State of Alaska
Department of Fish and Game
Public Review Nomination for Waters
Important to Anadromous Species

☐ Addition X Correction ☐ Deletion

Name of Waterbody (if known): 306-50-10890

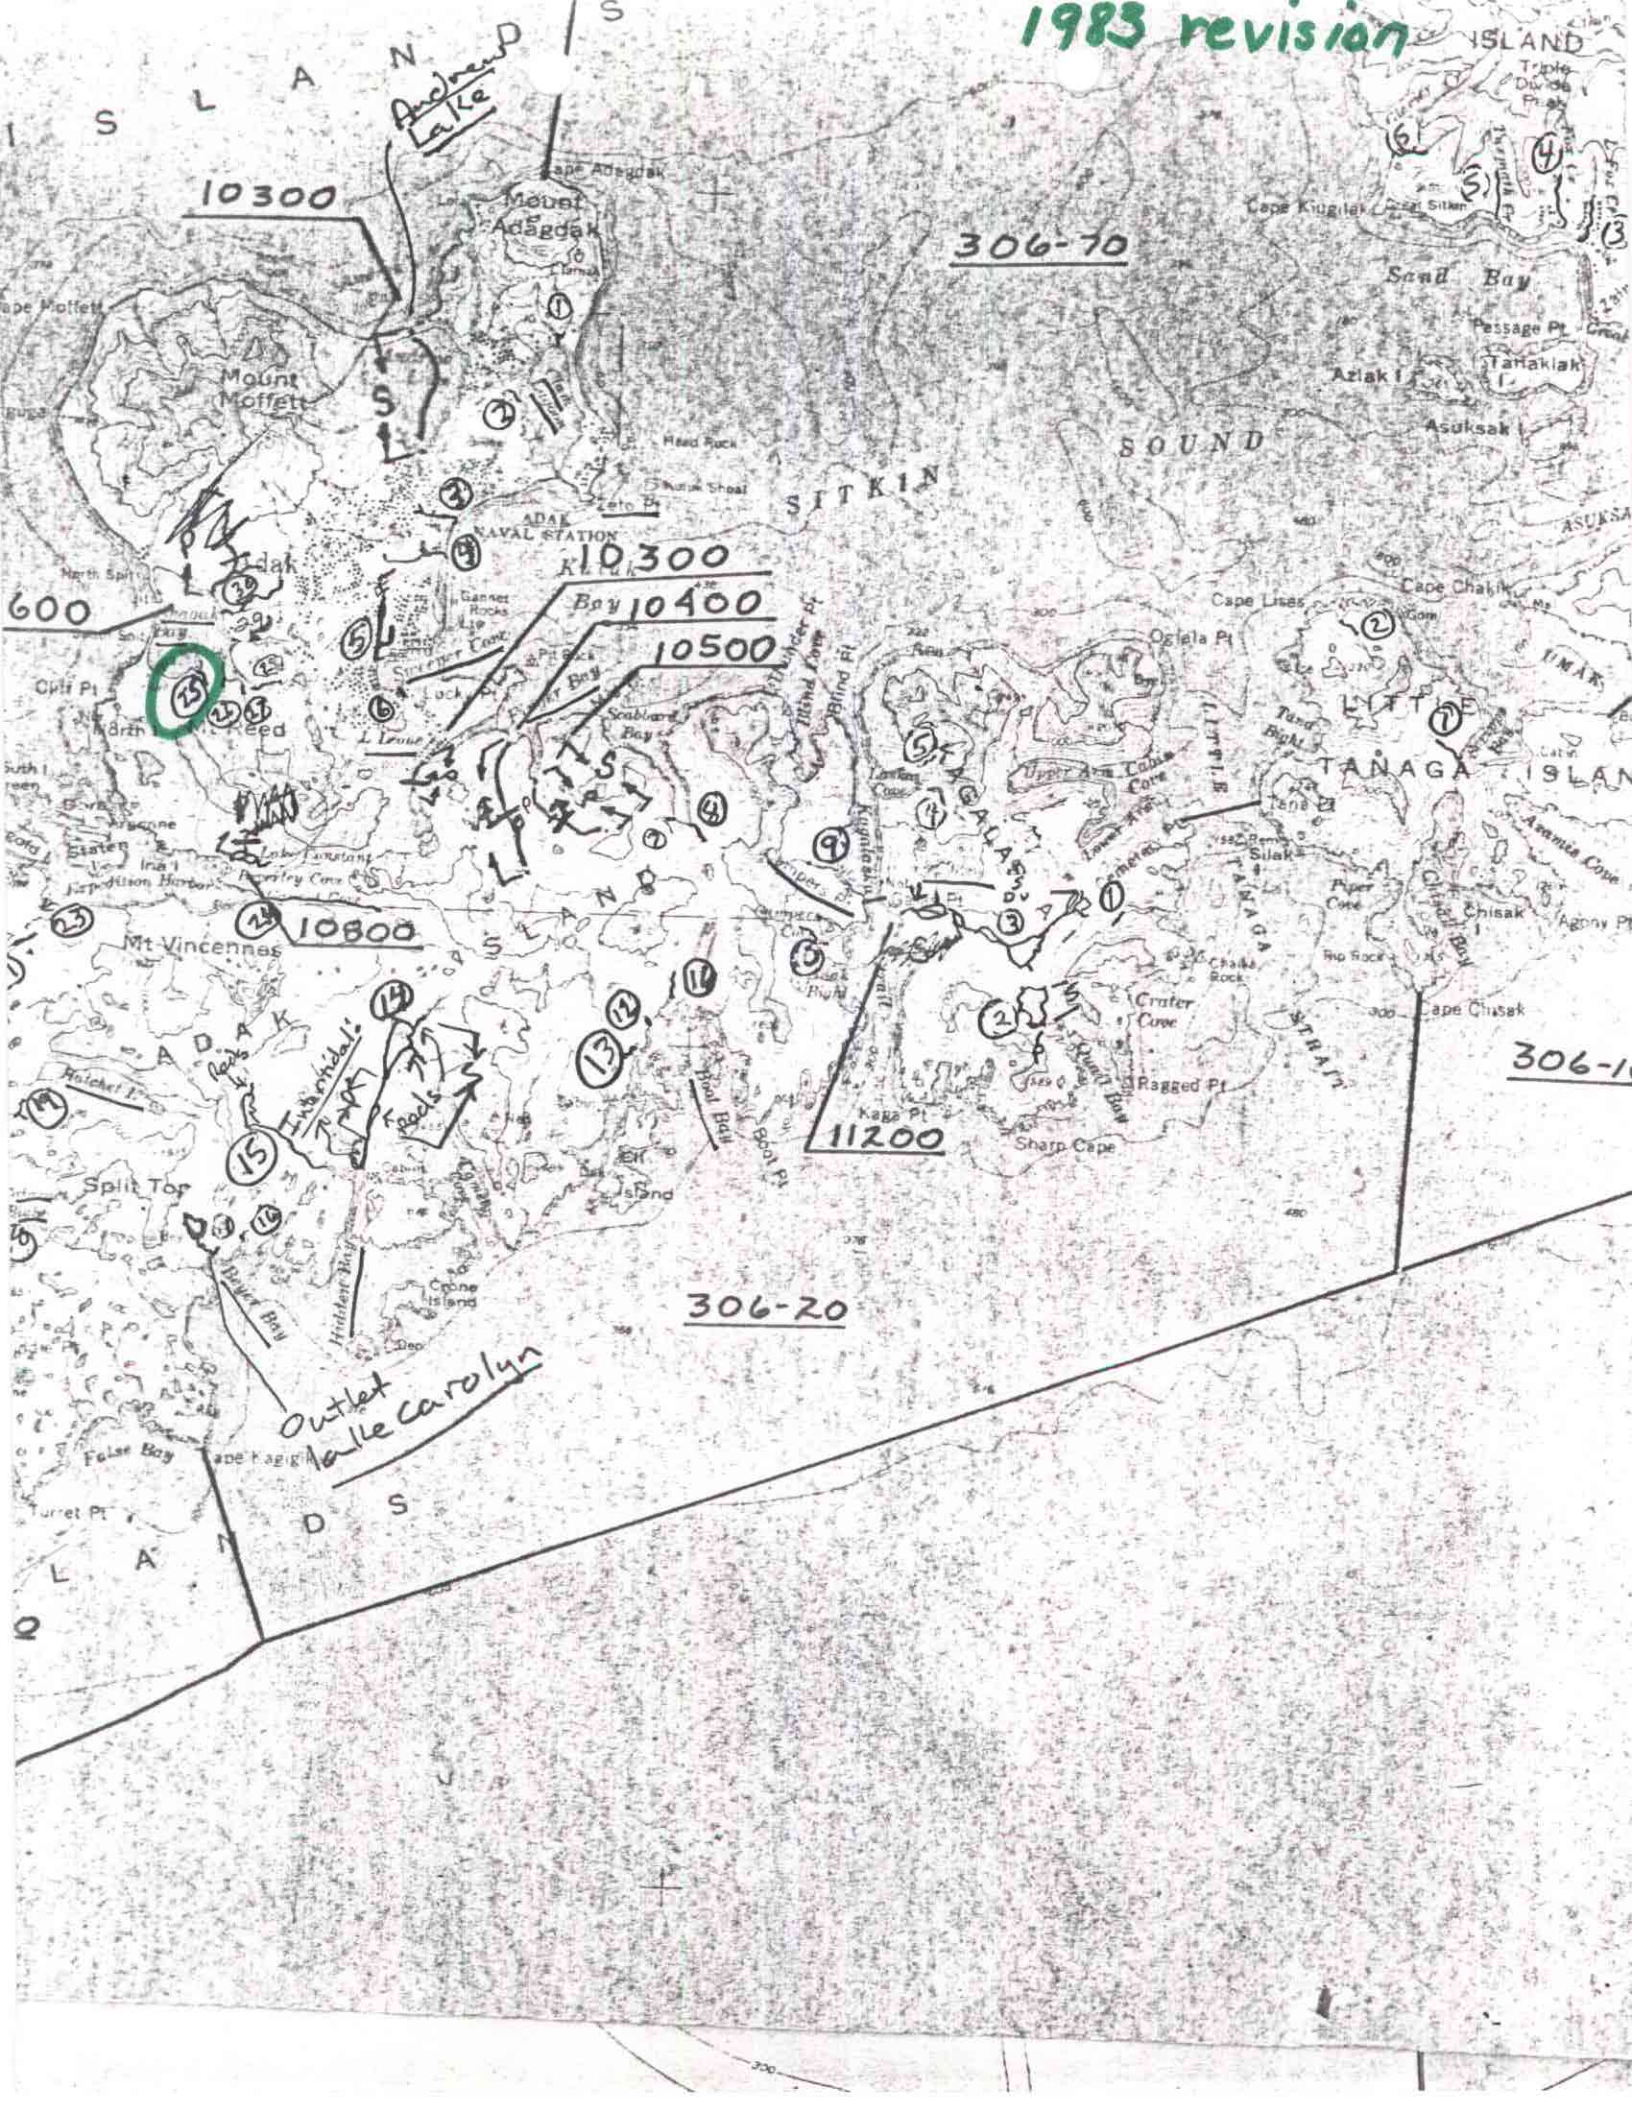
Stream was drafted as too long. Please correct upper point. Reference map from Pat Holmes and original nomination forms.

Your cartographer or possibly myself were a bit loose with the pen or outlining the length of a few streams. I have included a map with corrections outlined in red.
